Stakeholder Comment Form

Rule 6.6 Review – Recommendation Paper

Stakeholder: TransAlta

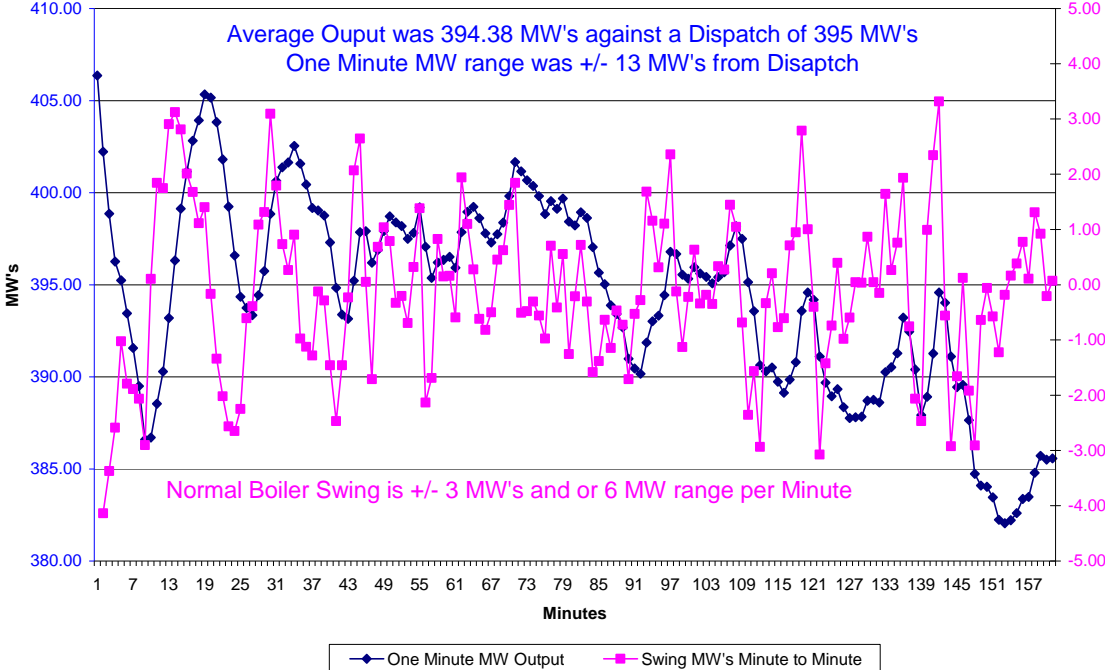
Section of Paper	Description	Stakeholder Comments
		Further, TransAlta reiterates that if the participant has operational issues and has communicated these to the AESO it should not be considered offside the rule. The current proposal does not ensure this.
<p>3.4 The rule should allow for normal fluctuations in output from generating units.</p>	<p>The new rule should consider momentary operational deviations from the dispatch level.</p>	<p>TransAlta would like to provide the attached chart showing unit fluctuations from one of our coal facilities in steady state. During the 2.5 hours shown the unit had a set dispatch point of 395 MW's. Thus all fluctuations were due to normal fluctuations of output from the generating unit. We are concerned that the deviations shown would be outside the proposed tolerance bands suggested by the AESO for steady state.</p> <p>Regardless of where the AESO sets the bands, there may be valid operational reasons for a unit to be generating outside of the tolerance bands. The rule needs to incorporate these periods of instability and allow unit operators to focus on their most important priority – reliability. Any rule which would consider the above plant, a typical coal plant with typical swings in generation, offside of a dispatch variance rule would in TransAlta's opinion be technically deficient</p> <p>Specific Analysis of TransAlta's coal unit against current and proposed dispatch variance rule</p> <p>This is a random 2 ½ hours from one of TransAlta's coal units with new boiler controls in Steady State. The one minute MW range was +/- 13MW's from dispatch yet the unit averaged 394.38MW's against a dispatch of 395MW's. The unit was within 99.84% of dispatch with a deviation of 0.62 MW's over the 2 ½ hours. The unit appears to be compliant; however, when tested against the current dispatch variance rule the unit is out of compliance a large portion of the 2 ½ hours. When tested against the newly proposed 2.5% or 10mws, the unit performs better, but is still out of compliance 3 times over the 2 ½ hour time period, with the last deviation lasting nearly 15 minutes.</p>

Section of Paper	Description	Stakeholder Comments
		<p data-bbox="932 305 1738 337" style="text-align: center;">MW Output and MW Swing with Constant Dispatch of 395 MW's</p>  <p data-bbox="760 1101 1906 1318">The AESO has repeatedly said that they do not support averages because “two wrongs do not make a right”. While TransAlta respectfully acknowledges the AESO’s position on this matter, the reality is that a healthy coal unit has a large degree of minute to minute variance by its very nature and to measure a coal unit against a specific moment in time versus of a rolling average will always result in a dispatch variance regardless of any meaningful band width.</p>

Section of Paper	Description	Stakeholder Comments
		<p>TransAlta recommends that the AESO and MSA incorporate a minimum 20 minute rolling average into their rule to smooth out normal minute to minute fluctuations of output. In addition, the AESO needs to be cognizant that any deviation outside this band is not necessarily non-compliance, and that the AESO needs to provide an outlet for participants to communicate these normal fluctuations without the need for a change in dispatch. If the AESO is concerned about participants intentionally averaging their dispatch over the 20 minute rolling average period the suggested inclusion of a prohibition on participants intentionally deviating from their dispatch level should alleviate this concern.</p>
<p>3.5 Preparation to provide Operating Reserves must be considered</p>	<p>The 15 minutes allowed for positioning to provide AS will be considered in the rule.</p>	<p>TransAlta completely agrees.</p> <p>With the dispatch ramp rate requirement, in the event of conflict between the AESO Technical Requirement for Regulating Reserve version 2.0 dated December 10, 2004 Test description for AGC response (Section 4.1) and this new rule, which will take precedence ?</p>
